WATER QUALITY MEMORANDUM

Utah Coal Regulatory Program

RE: First Quarter 2016 Water Monitoring, PacifiCorp, Deer Creek Mine.
C/015/0018, Task ID #5123

Wells

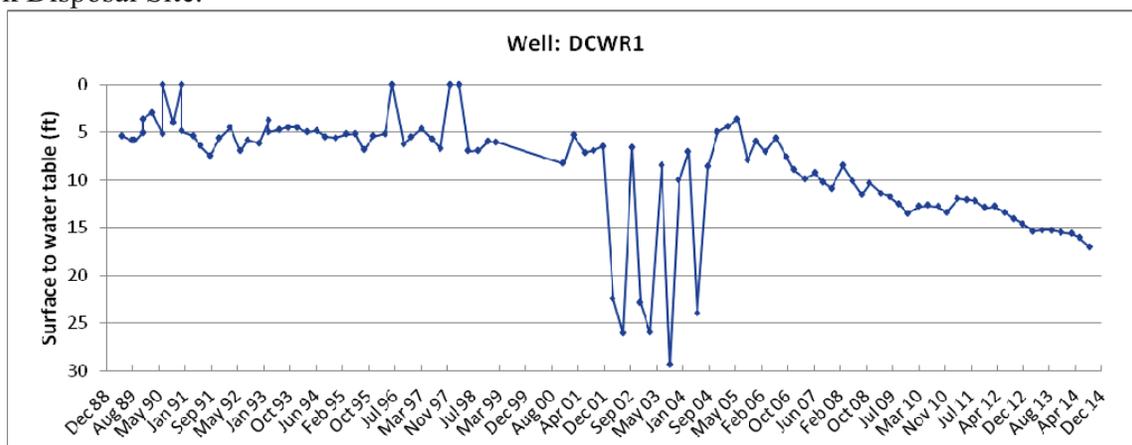
The Deer Creek Waste Rock well has been dropping since 2006 (following a small rise in 2004-2005). These changes are probably from factors other than disposal of waste rock at this site: a similar drop in water level is seen at WCWR1 at the Cottonwood/Wilberg Mine Waste Rock Disposal Site.

This well is no longer a Pacificcorp water monitored site. It is now monitored by Bowie as the Deer Creek Waste Rock site.
